1 ADDENDUM 1: DATE: 10-16-07

# MD 355 (ROCKVILLE PIKE) AND TWINBROOK PARKWAY / ROLLINS AVENUE

## TRAFFIC SIGNAL PLAN

TS NO. 1077A | DRAWING NO. 1 OF 3 | SHEET NO. 8 OF 42

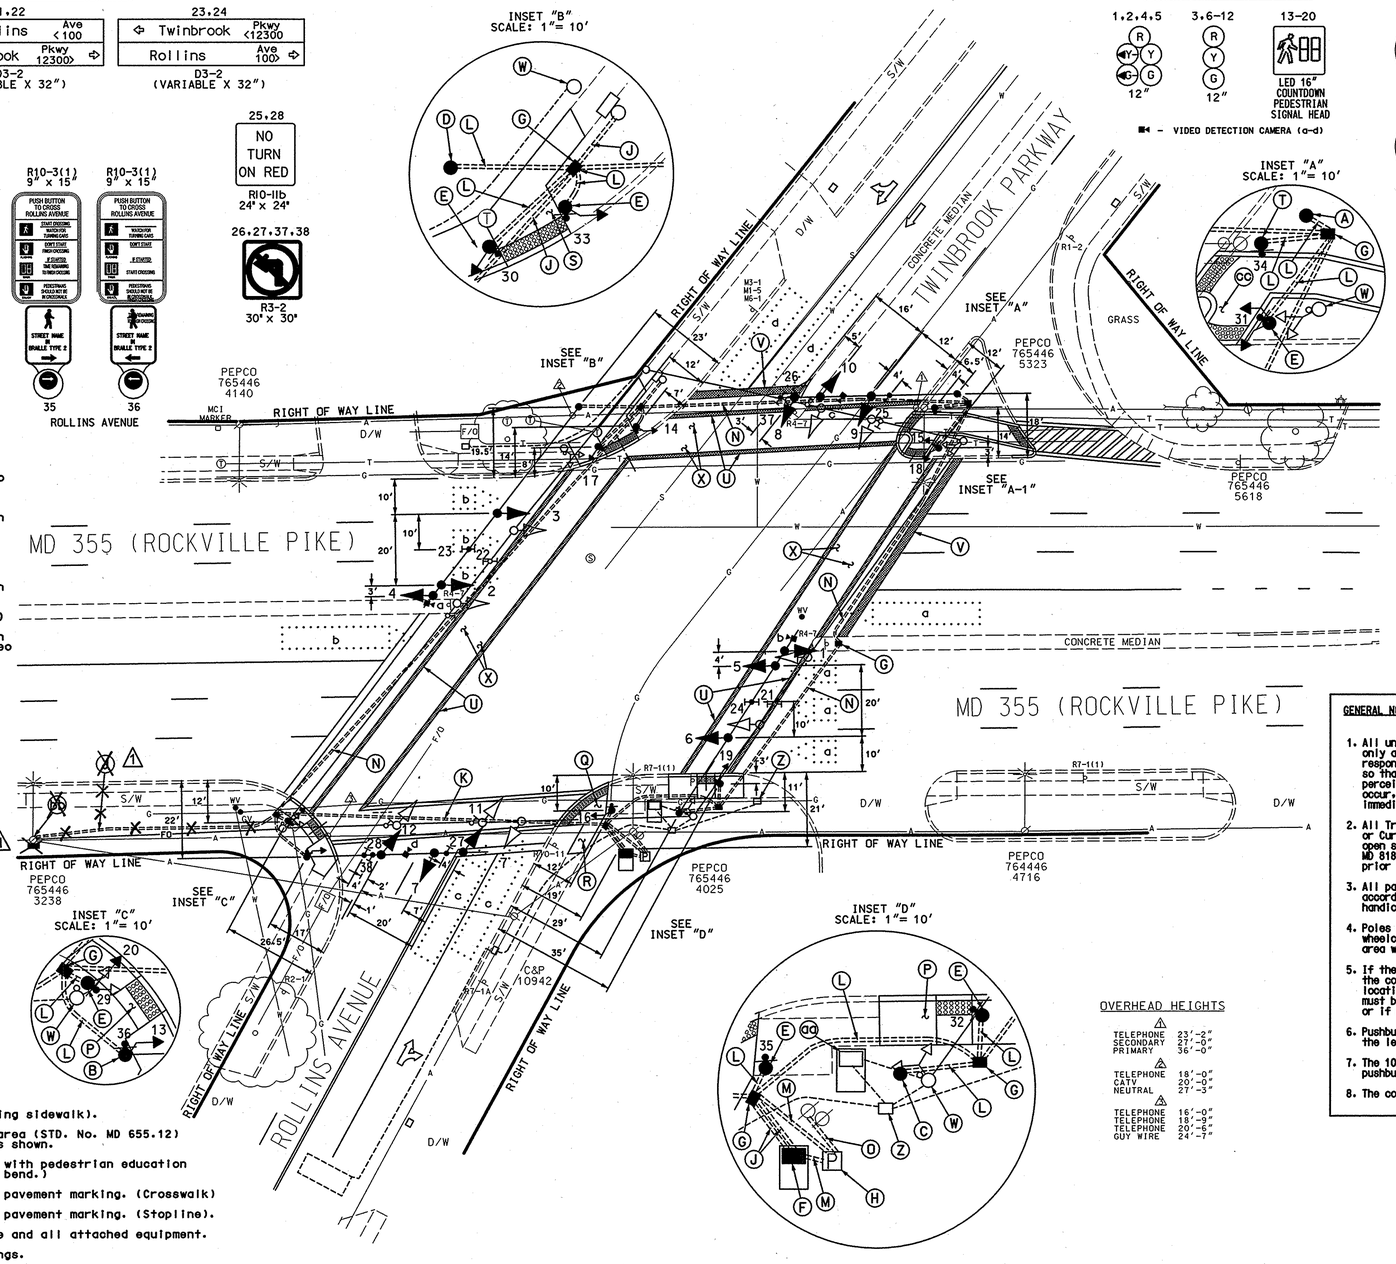
1 O. Install 3" polyvinyl chloride electrical conduit (Schedule 80) (trenched) with 50' of ~~3 wire~~ 1 conductor (No. 250 KCMIL) for proposed underground electrical power service by PEPCO to base of utility pole.

1 ~~bb. Install 15' 4" PVC riser, 4" weatherhead and splice cabinet, for interconnect cable, onto existing utility pole. Pull back overhead interconnect cable to this location and terminate in splice cabinet. (Note: Montgomery County shall supply cabinet and shall make all final connections in splice cabinet. Contact Keith Lord (301) 674-8965.)~~
